Certificate of Appropriateness Case Report

HEARING DATE: MARCH 16, 2011

Filing Date: December 16, 2010
Case No.: **2010.1139A**
Project Address: **1067 TENNESSEE STREET**
Historic Landmark: Dogpatch Historic District
Zoning: RH-3 Zoning District
40-X Height and Bulk District
Block/Lot: 4108/010
Applicant: Reza Khoshnevisan
Sia Consulting Corporation
1256 Howard Street
San Francisco, CA 94103
Staff Contact Richard Sucre - (415) 575-9108
richard.sucre@sfgov.org
Reviewed By Timothy Frye - (415) 575-6822
tim.frye@sfgov.org

(N) FRONT ELEVATION
 1/4" = 1'-0"

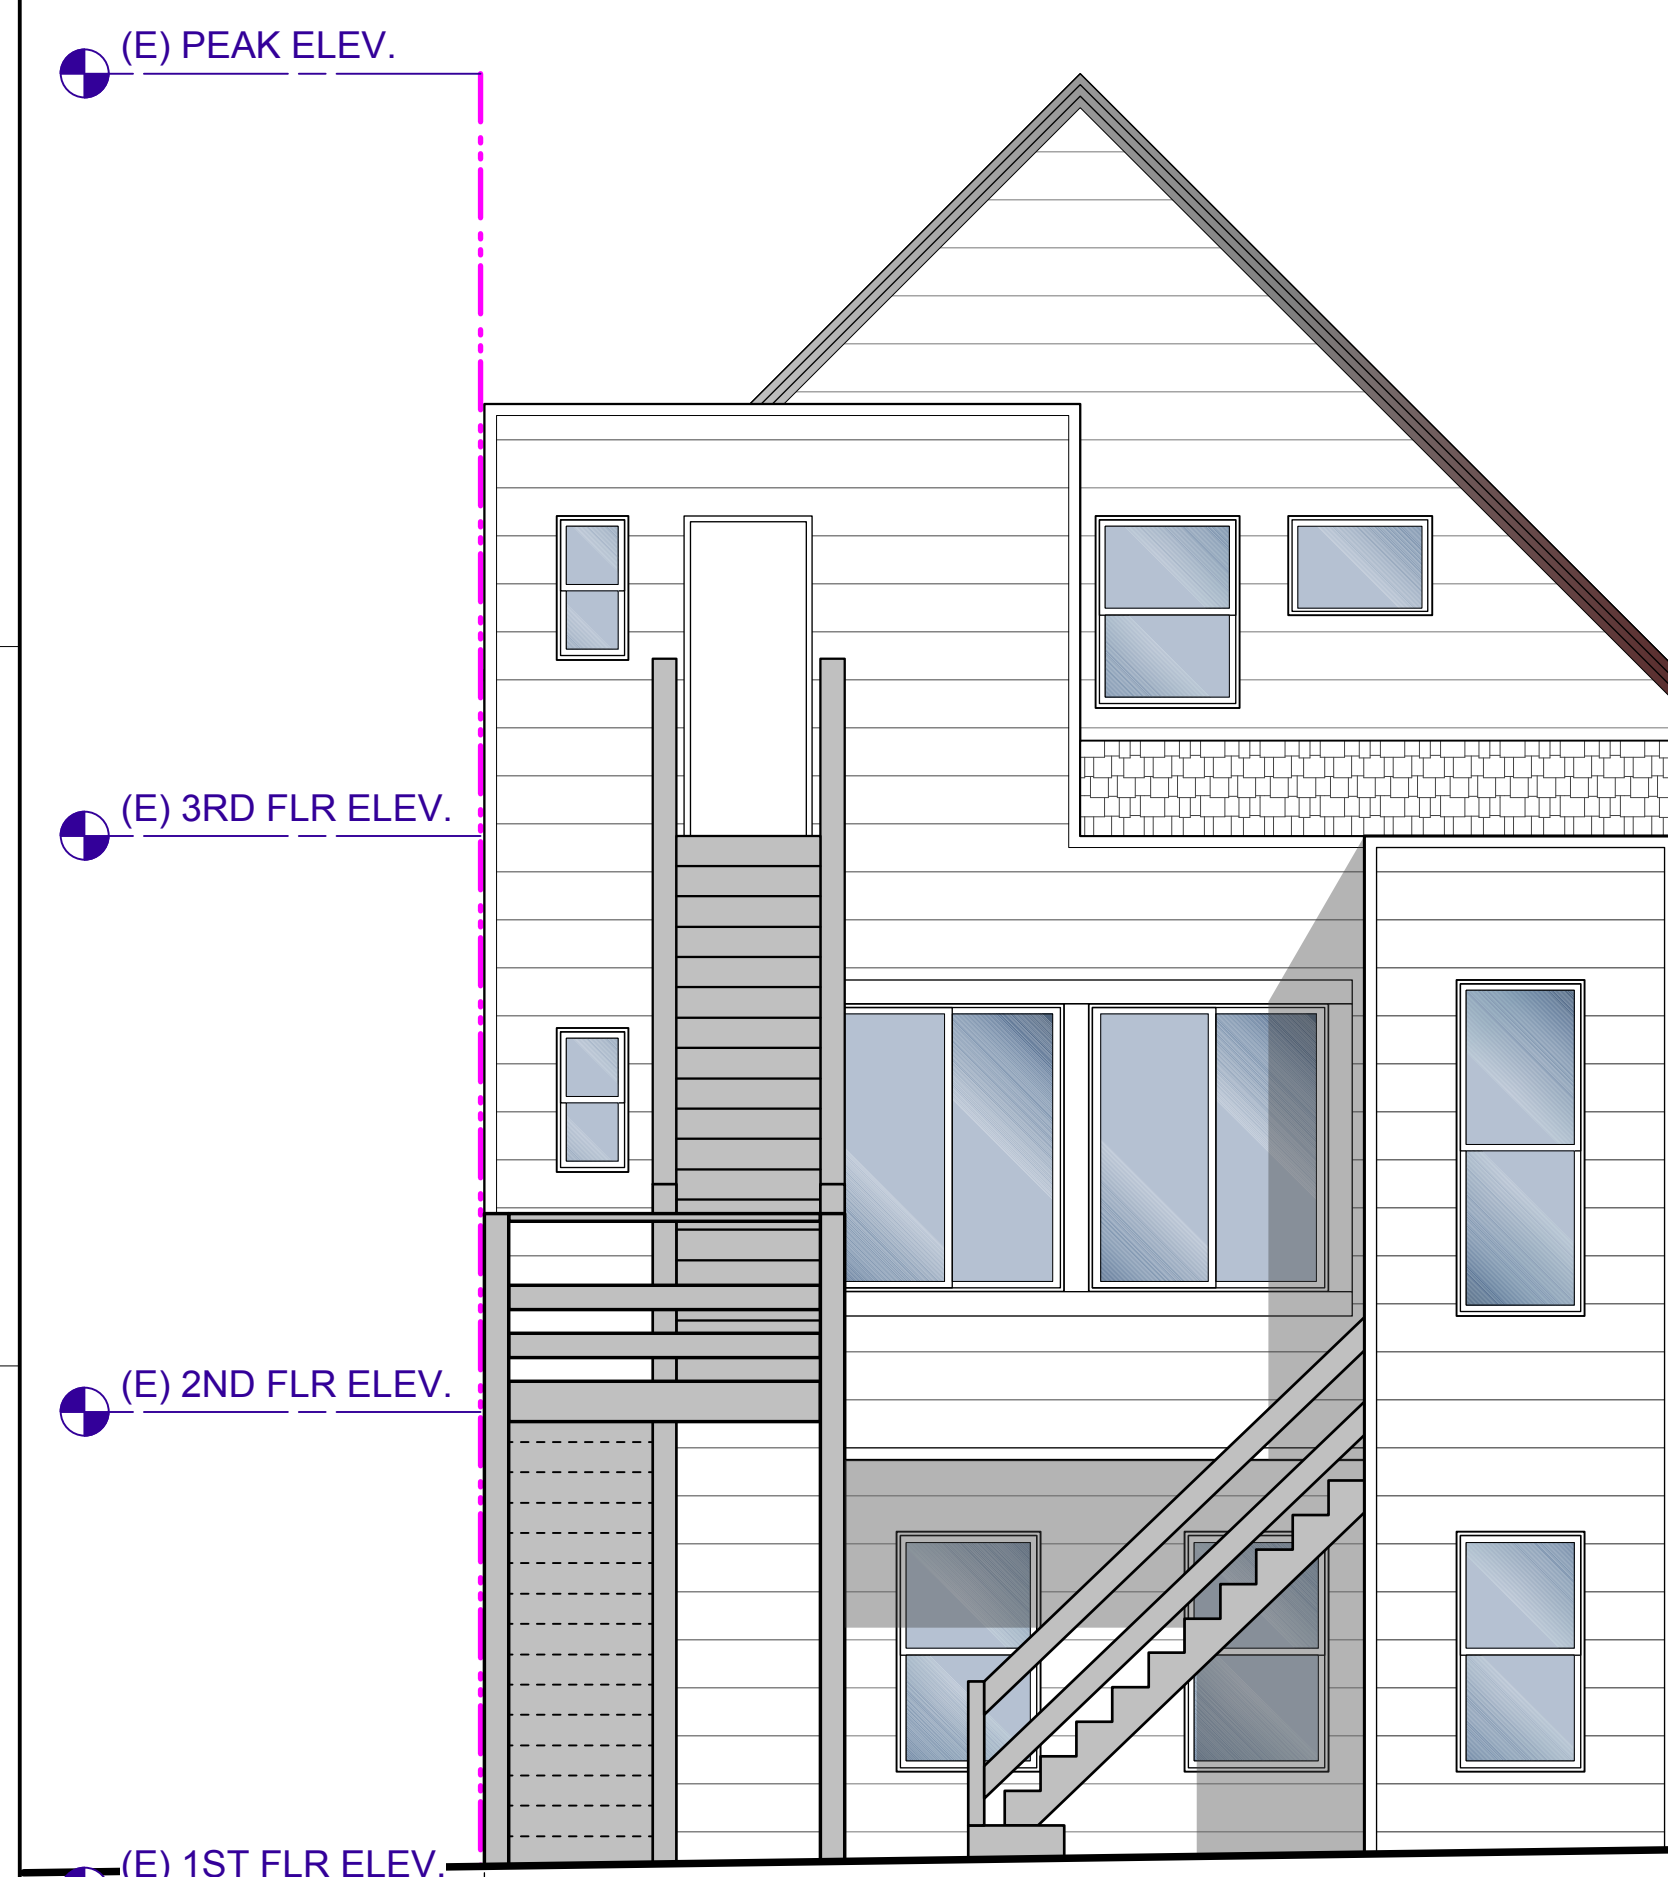
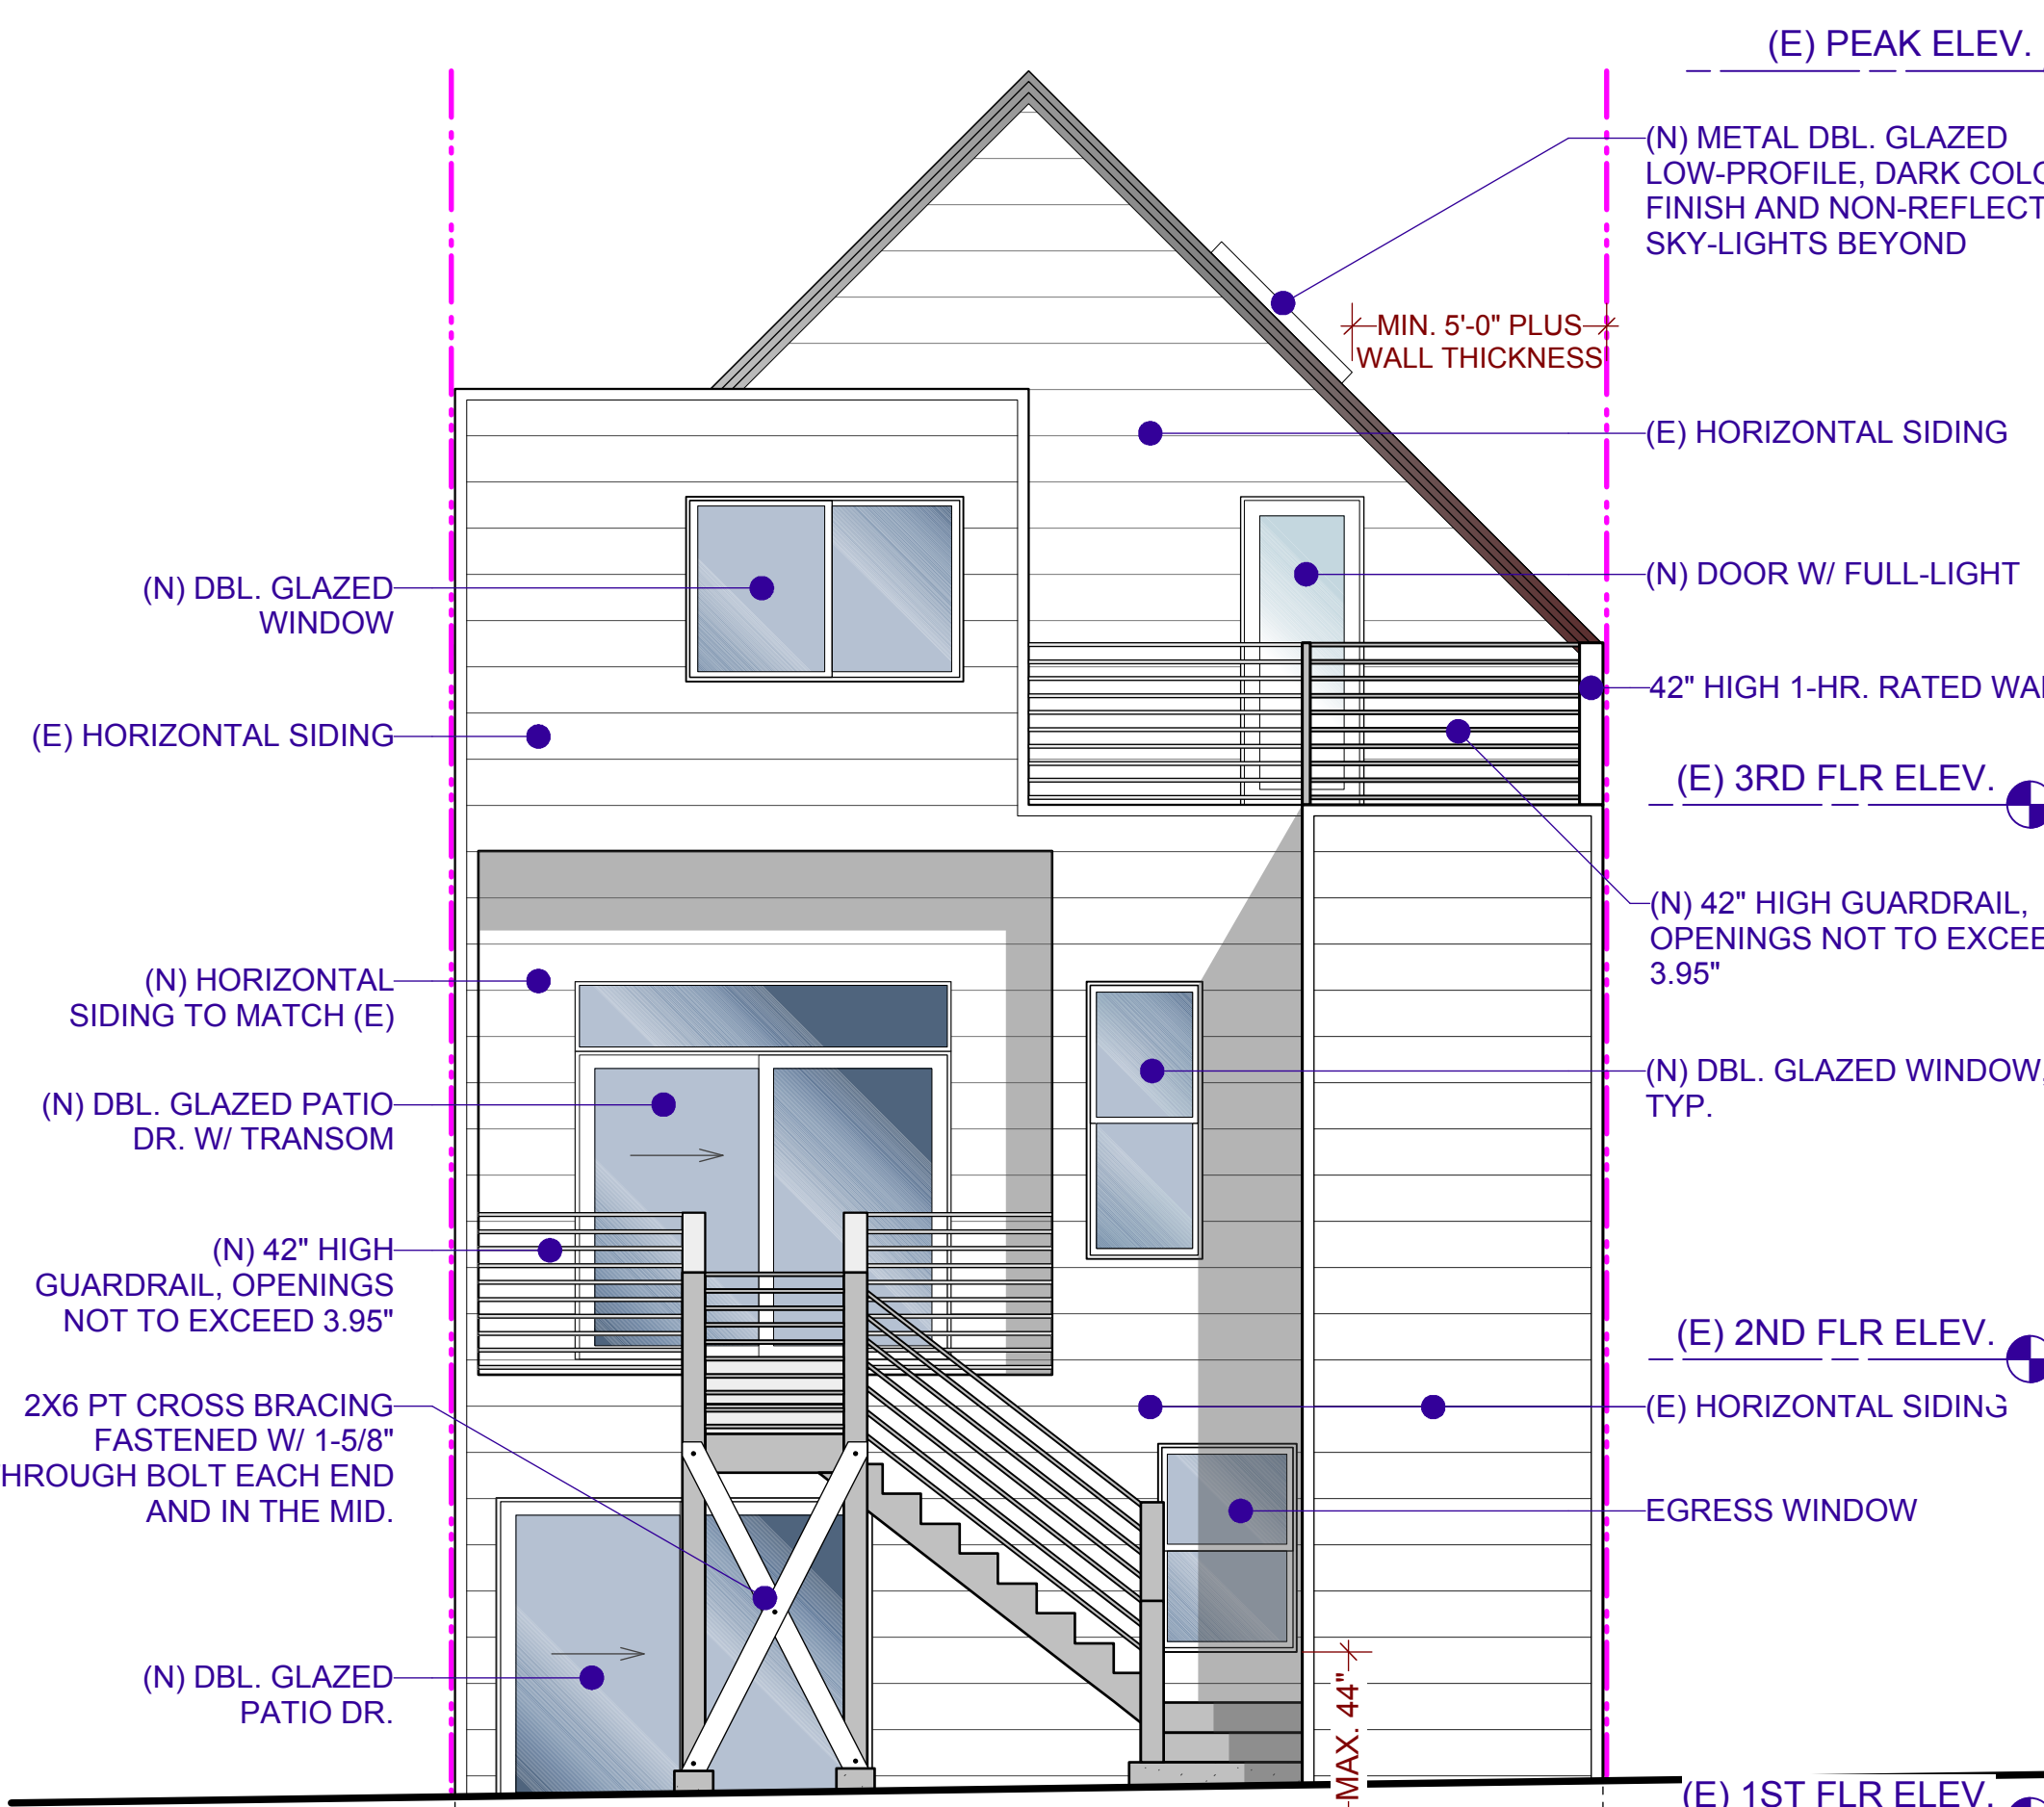
Primary Façade Alterations: The existing façade is covered in a sprayed-on “gunnite-like” substance, which appears to be a textured paint, and currently features metal-sash slider windows on the second floor. The proposed project will clean and repaint the primary façade facing Tennessee Street, and will replace the existing metal-sash windows with wood-sash double-hung windows.

The replacement of the wood-sash windows on the second floor will assist in bolstering the historic integrity of the subject property, and is a compatible alteration that will not affect the character of the surrounding historic district. Wood-sash double-hung windows are commonly found on historic residential properties in the Dogpatch Historic District.

As specified on the architectural drawings, the exterior treatment will remove paint and dirt using the “gentlest means possible,” which has been defined as:

This treatment appears to be appropriate. To ensure that the work is completed accordingly, Planning Department Preservation staff will review a sample of this treatment to ensure that the existing paint is being removed using “gentlest means possible.” This treatment will not adversely impact the building’s historic fabric, and will assist in improving the current condition of the property.

Rear Façade Alterations: The proposed project includes alterations to the rear façade that consist of: the removal of all existing rear windows, rear doors, and rear stairs; installation of new windows on all levels; installation of new glazed patio doors on the ground and second floors; installation of one rear staircase; and construction of a roof deck on the third floor. The rear façade is not visible from the public right of way, and does not possess any significant character-defining features (other than the historic massing), which contribute to the Dogpatch Historic District. Therefore, alterations to the windows and doors on this façade and the installation of a new rear staircase will not adversely impact the historic character of the subject property or surrounding historic district. To ensure compatibility with adjacent properties, the proposed project will retain the horizontal rustic wood siding, which is found throughout the historic district. The new windows and doors are styled in a contemporary manner. No exterior additions are planned on the rear façade and the building will retain its characteristic Queen Anne detailing. Overall, the rear façade alterations do not impact the surrounding historic district or the historic status of the subject property.

1. As part of the Building Permit, a sampling of cleaning and repainting of the exterior street façade shall be reviewed by Planning Department Preservation staff prior to initiation. This sampling should occur in a discrete, minimally-visible location and should test all cleaning solvents and

solutions to be used in removing the existing paint from the exterior façade. Staff shall approve of the proposed treatment if deemed to be the “gentlest means possible.”
